MILITARY SPECIFICATION SHEET

ADAPTER, CONNECTOR, COAXIAL, RADIO FREQUENCY,
(BETWEEN SERIES BNC TO SERIES N), CLASS 2, STRAIGHT PLUG

This amendment forms a part of military specification sheet MIL-A-55339/18, dated 6 May 1975, and is approved for use by all Departments and Agencies of the Department of Defense

FIGURE 2, delete and substitute

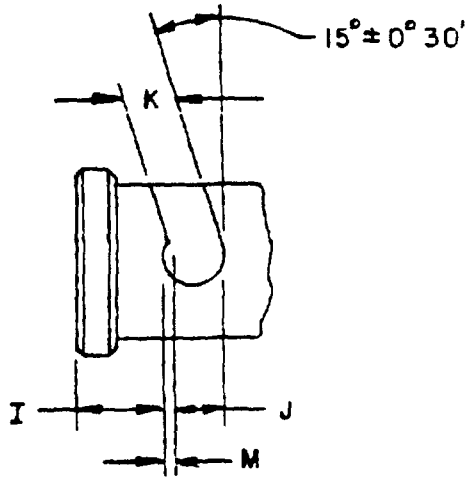
FIGURE 2, maximum column Add dimension E " 230 (5 84)', dimension L ' 040 (1 02)', and dimension P " 228 (5 74)"
